**ADDENDUM**

**ADDENDUM #1**

**CONCOURSE ROOF ADDITION  
GWTA TRANSFER CENTER  
CONCOURSE ROOF ADDITION  
for the  
CITY OF GOLDSBORO  
JUNE 16, 2021**

Sheet  
**E1.1**  
2 Of 2

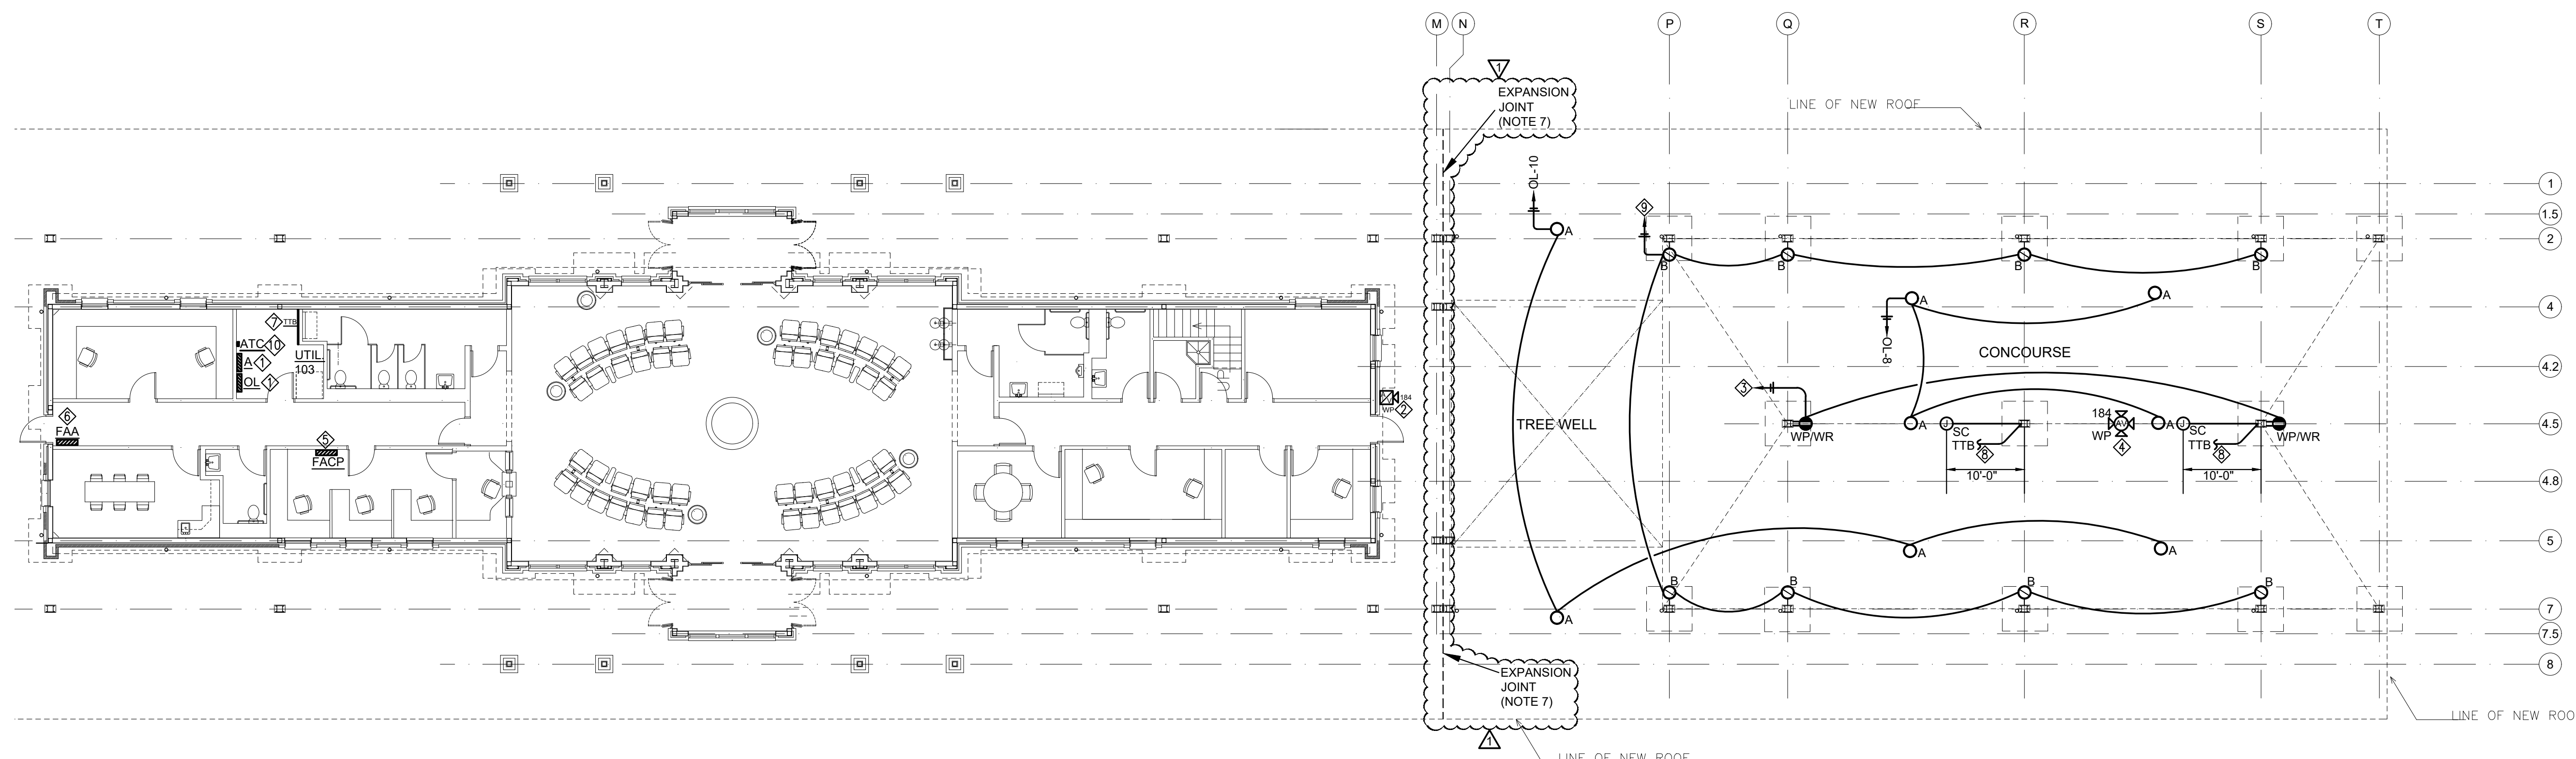
1. Refer to Sheet #A2.1. Change location of column mounted signs at Column #R7 to Column #Q7.
2. Refer to Sheet #A2.1. Add one sign each at Columns #R4.5 and P2.
3. Refer to Sheet #E1.1: Install raceway expansion fittings at new expansion joint areas. Refer to revised Sheet #E1.1 for more information.

- ROUTE NEW CONDUITS FROM CONCOURSE ROOF TO EXISTING BUILDING IN SUCH A MANNER SO AS TO LIMIT AS MUCH AS POSSIBLE, THE QUANTITY OF CONDUITS CROSSING THE EXPANSION JOINT AREA. FURNISH AND INSTALL UL LISTED AND APPROVED EXPANSION JOINT FITTINGS FOR EACH SIZE AND TYPE OF CONDUIT AT THE EXPANSION JOINT LOCATION. EXPANSION FITTINGS SHALL HAVE CAPACITY TO ALLOW 2" OF MOVEMENT IN EITHER DIRECTION (TOTAL MOVEMENT OF 4"). INSTALL FITTINGS PER MANUFACTURER'S SPECIFICATIONS.
